SERVICE BULLETIN

CARQUEST CORPORATION

CARQUEST FUEL PUMPS

TIP TO HELP ELIMINATE NOISE WHEN INSTALLING E7006 FUEL PUMP IN VARIOUS JEEP APPLICATIONS.

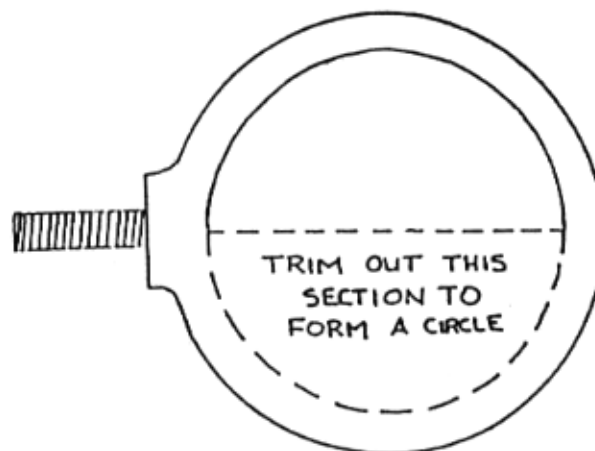
The fuel pump carrier on various Jeep applications may be equipped with a retaining ring that is not a full circle cutout. When the E7006 is installed, the retaining ring can come in contact with the top of the fuel pump causing noise to be transmitted into the passenger compartment.

To eliminate this potential problem, the installer may choose to trim out the retaining ring to allow the fuel pump to sit in the retaining ring unrestricted. Please refer to the drawing below for reference.
